Case #: ZBA 2013-42
Date: September 26, 2013
Recommendation: Conditional Approval

PLANNING STAFF REPORT

Site: 47 Hunting Street

47 Hunting Street: house and (r) left side yard, (l) right side yard, aerial (bottom)

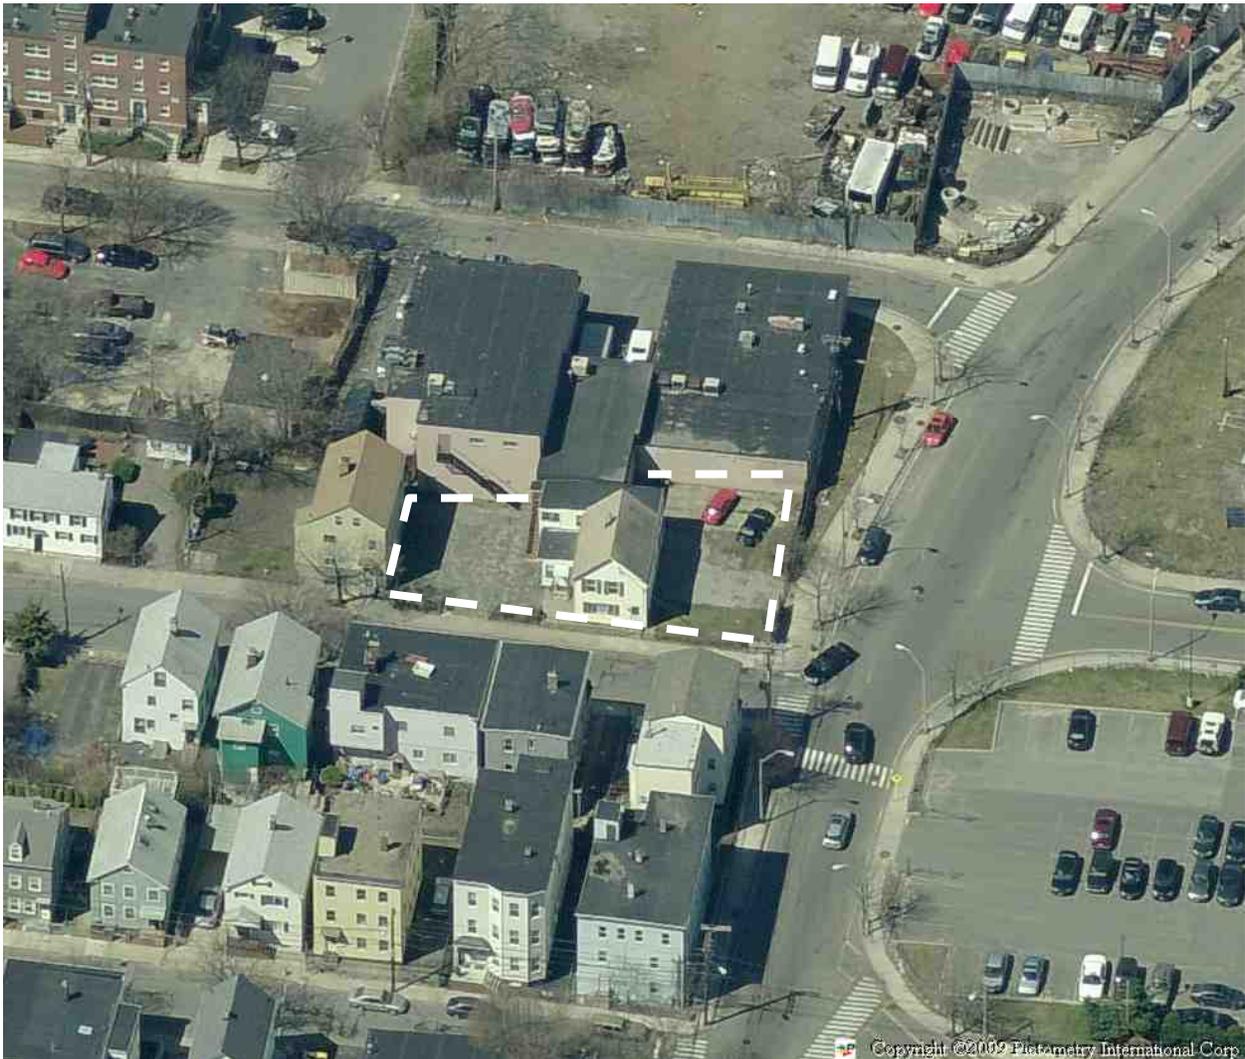
1. Subject Property: The subject property is comprised of three parcels totaling approximately 5,565 square foot lot on which sits a 2 ½ story 2-family structure. The lot is located on the corner of

Hunting and South Streets. There is a paved parking area to the left of the house with a curb cut on Hunting Street and a parking area to the right of the house that is a mix of gravel, grass and dirt with a curb cut on South Street.
